Agenda Item # 3

SUB-003105-2024

8000 Foxfire Drive

Foxfire II Subdivision

DETAIL SITE PLAN

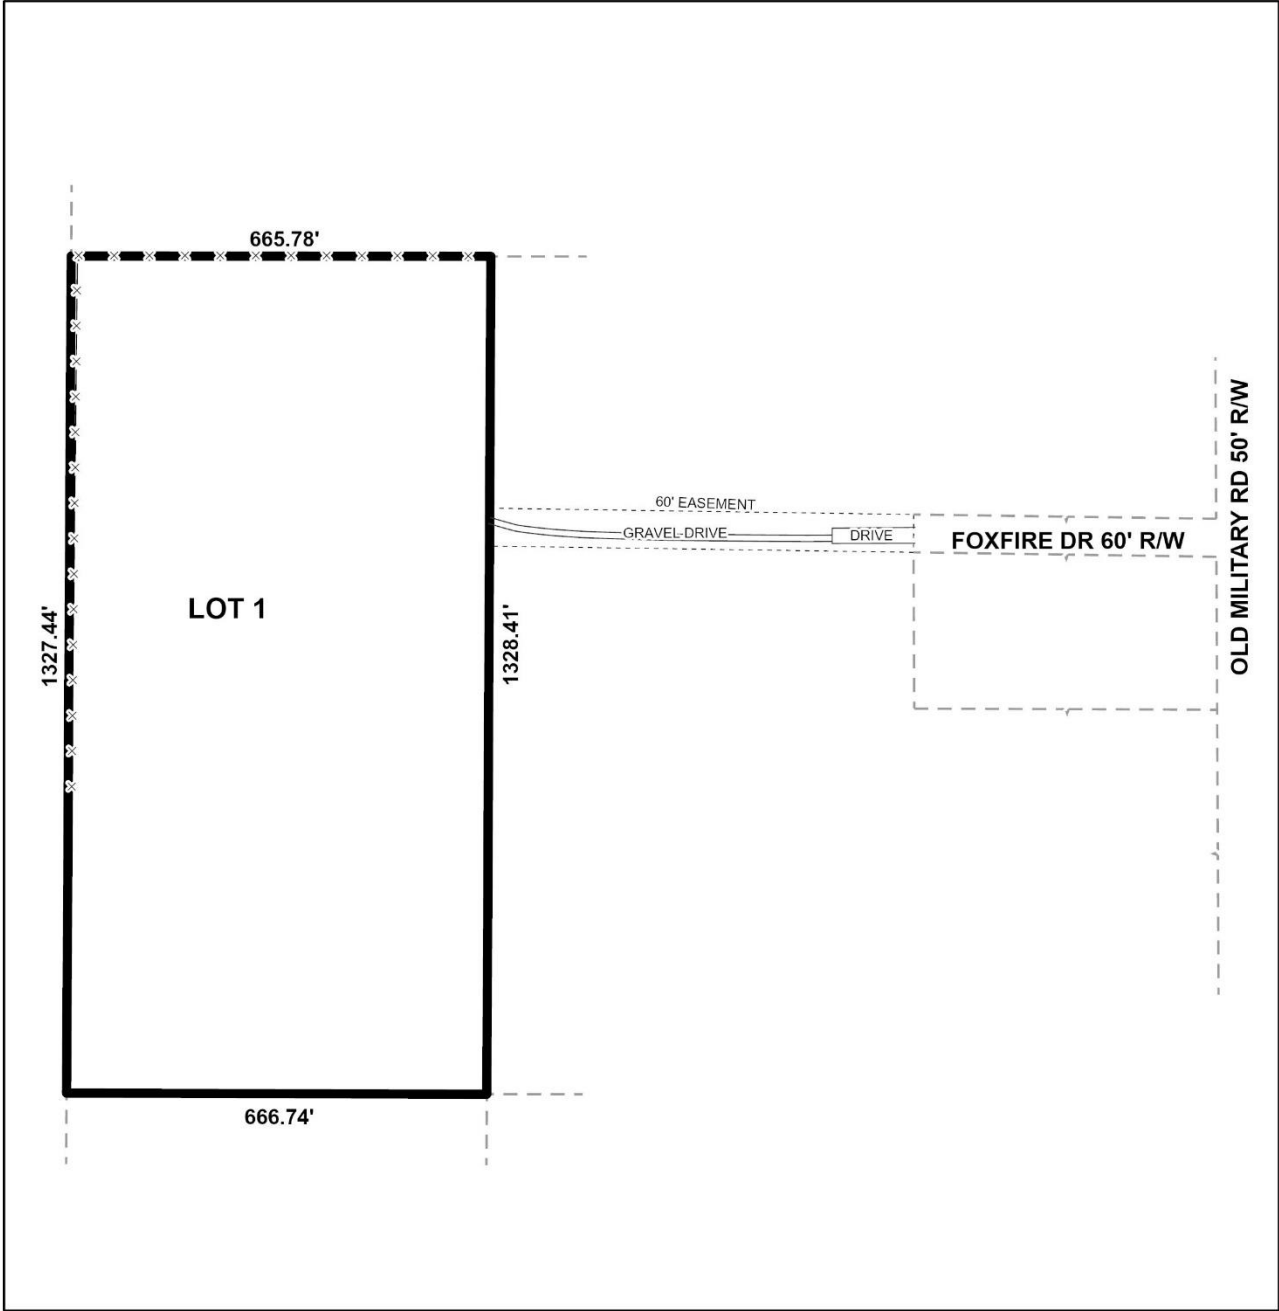
As proposed, Lot 1 does not have direct frontage onto a public street, as required by Section 6.C.4. of the Subdivision Regulations. The preliminary plat does, however, illustrate a 60-foot ingress and egress easement which grants access to the proposed lot from Foxfire Drive, a minor street without curb and gutter illustrating a compliant 60-foot right-of-way. It should be noted that Section 64-3-2.A.1. of the Unified Development Code (UDC) allows access to be provided by a recorded dedicated easement, but a waiver of Section 6.C.4. of the Subdivision Regulations will be required for approval. Such a waiver may be appropriate considering the property has existed in its current configuration since before it was annexed into city limits in 2023.

The lot exceeds the minimum size requirements for lots served by public water and sanitary sewer in a CW, Commercial Warehouse Suburban District, however, the preliminary plat does not label the lot's size in both square feet and acres. If approved, the Final Plat should be revised to label the lot's size in both square feet and acres, or placement of a table on the Final Plat with the same information will suffice.

The preliminary plat does not illustrate a compliant front yard setback. As such, if approved, the Final Plat should be revised to illustrate a 15-foot minimum building setback where the ingress/egress easement abuts the subject site, in compliance with Article 2 Section 64-2-17.E. of the Unified Development Code.

1. Revision of the Final Plat to label the lot's size in both square feet and acres or provision of a table on the Final Plat providing the same information;
2. Revision of the Final Plat to illustrate a 15-foot setback where the ingress/egress easement abuts the subject site, in compliance with Article 2 Section 64-2-17.E. of the Unified Development Code;
3. Compliance with all Engineering comments noted in this staff report;
4. Placement of a note on the Final Plat stating the Traffic Engineering comments noted in this staff report;
5. Compliance with all Urban Forestry comments noted in this staff report; and
6. Compliance with all Fire Department comments noted in this staff report.
